Check of stick attachment in the rear cockpit.

LTA Nr. 2/63

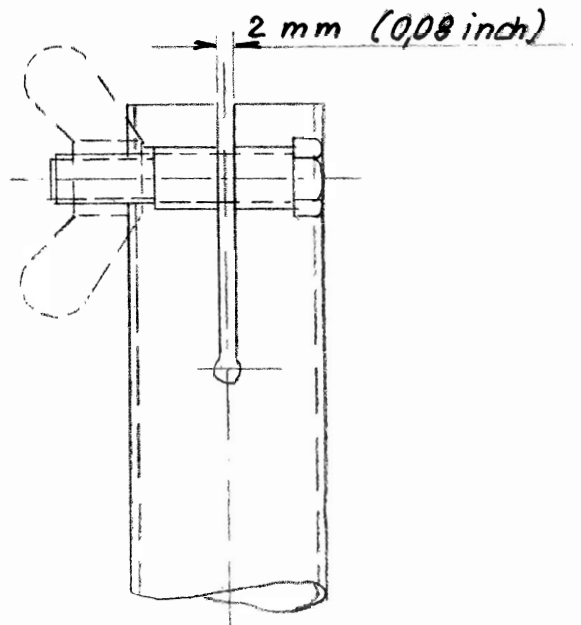
Probable by deformation on the tube nozzles there has been found a loose stick although the wing nut was fastened.

- 1) Check if the both tube nozzles are not bended by the screw so that it is possible to pull out the stick even when the wing nut is fastened.
- 2) Check the gap for the wide of 2 mm (0,08 inch). If neccessary make it wider by a file. (See scetch). With fastened wing nut, the stick must be reliabely fixed.
